DCRDR IN-PROGRESS AUDIT REPORT
FOR
WISCONSIN PUBLIC SERVICE CORPORATION'S
KEWAUNEE NUCLEAR POWER PLANT

May 31, 1984

U.S. Nuclear Regulatory Commission
Washington, D.C. 20855

Exhibit 2. Emergency Event Sequences Selected for Task Analysis

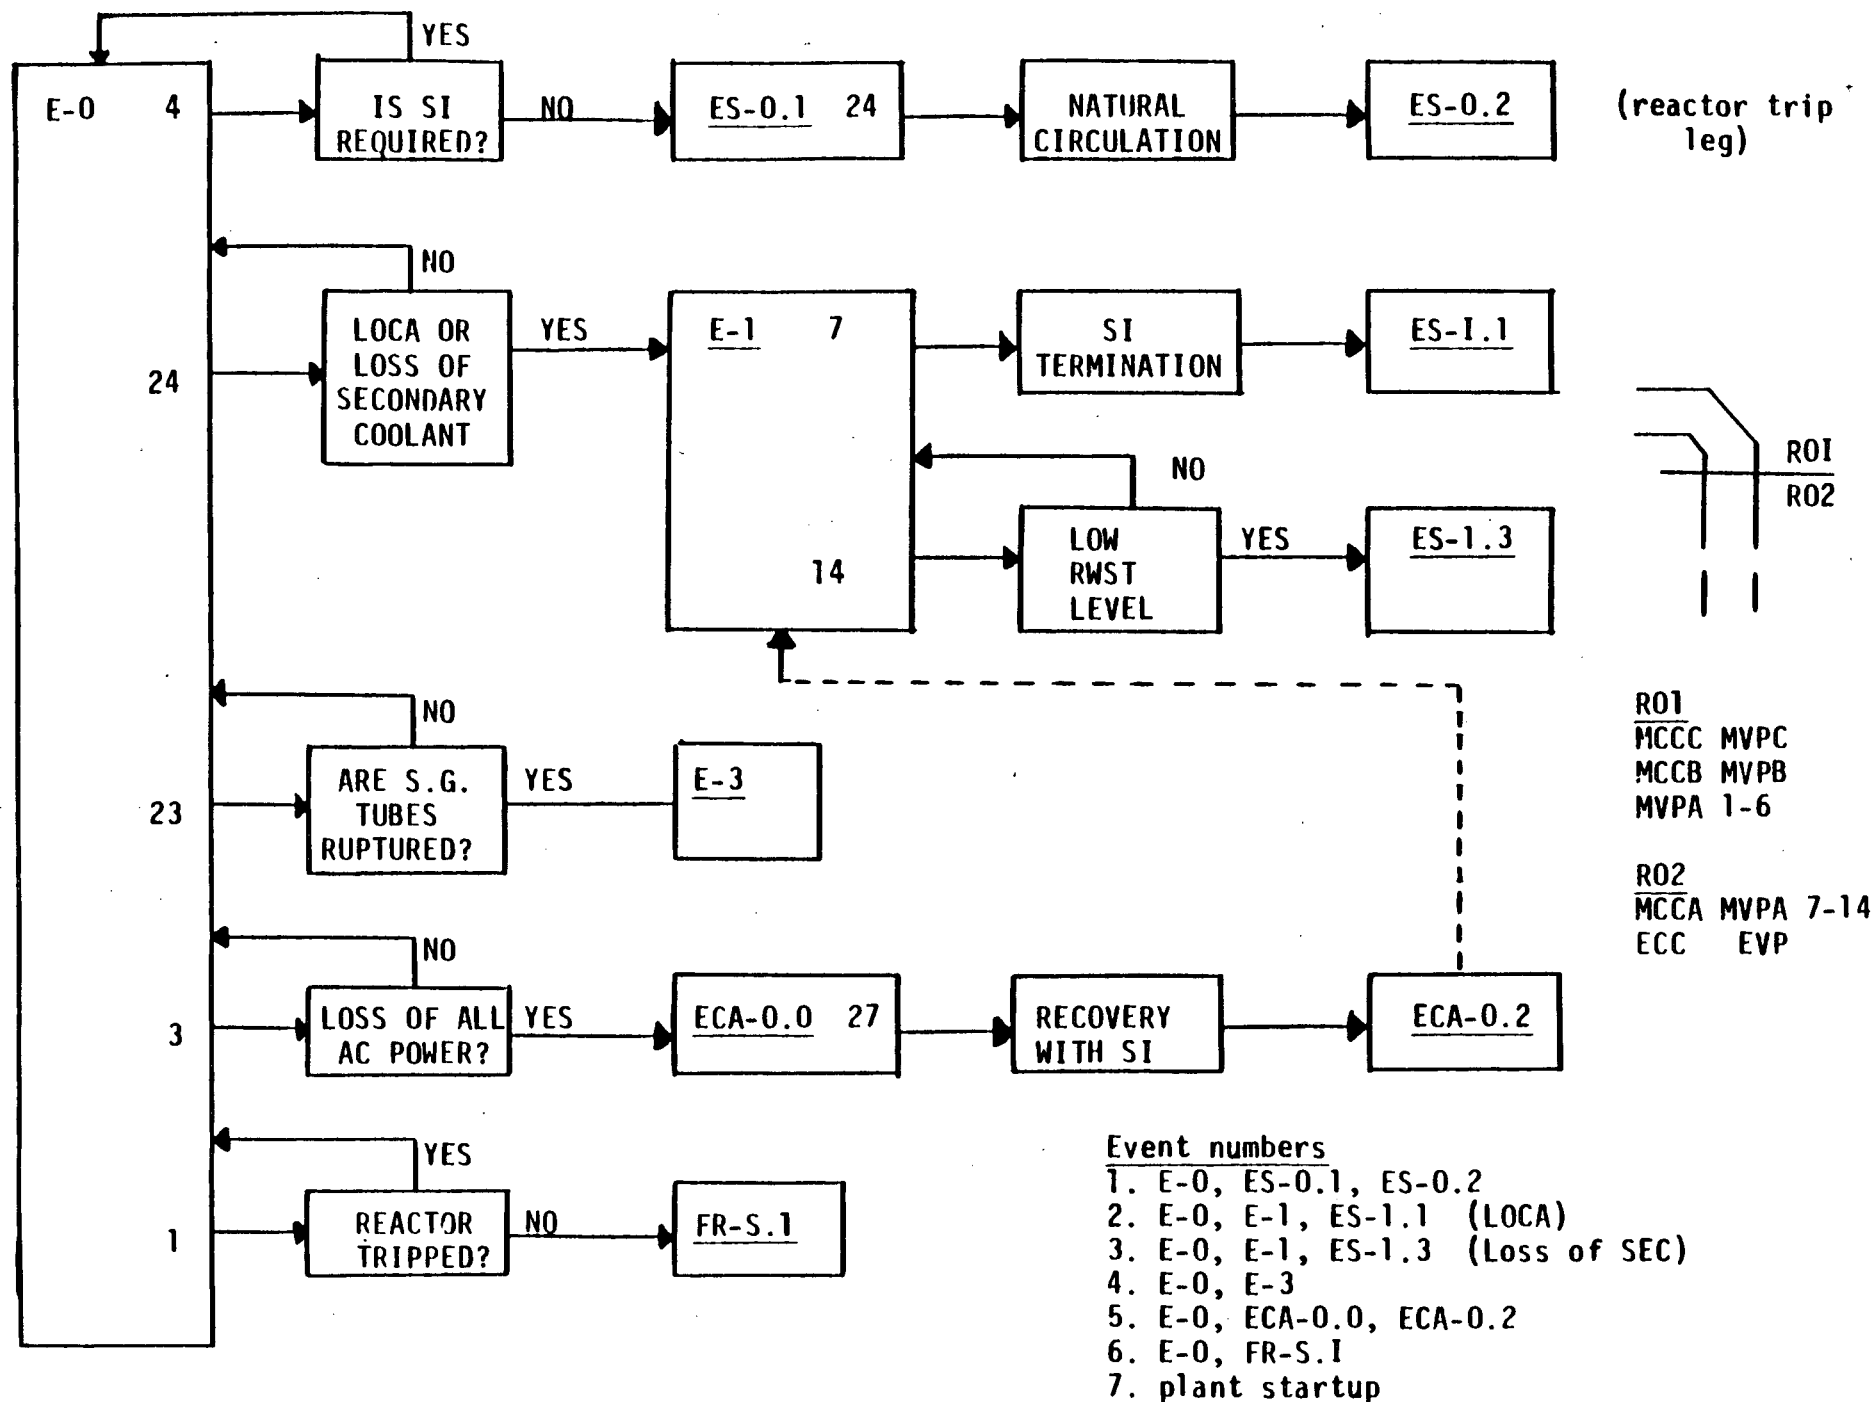
The DCRDR team identified 7 event sequences which cover many major functions and operator tasks that are required to implement the emergency operations and startup (see Exhibit 2). NUREG-0737 Supplement 1 requires that all operator functions and tasks needed to implement the emergency procedures be analyzed. This does not mean that every task has to be analyzed every time it occurs. NUREG-0700 Subsection 3.4.2.4 states that in many cases the set of operator tasks associated with the operator function/system interface will be identical for more than one sequence. In those cases, the analysis of the task requirements need not be repeated for each sequence. However, the NRC audit team could not substantiate that all

operator functions and tasks were covered at least once in the 7 events selected. As a result, the NRC audit team recommended that a more systematic approach be developed and implemented to substantiate that all operator functions have been identified and evaluated in the task analysis.
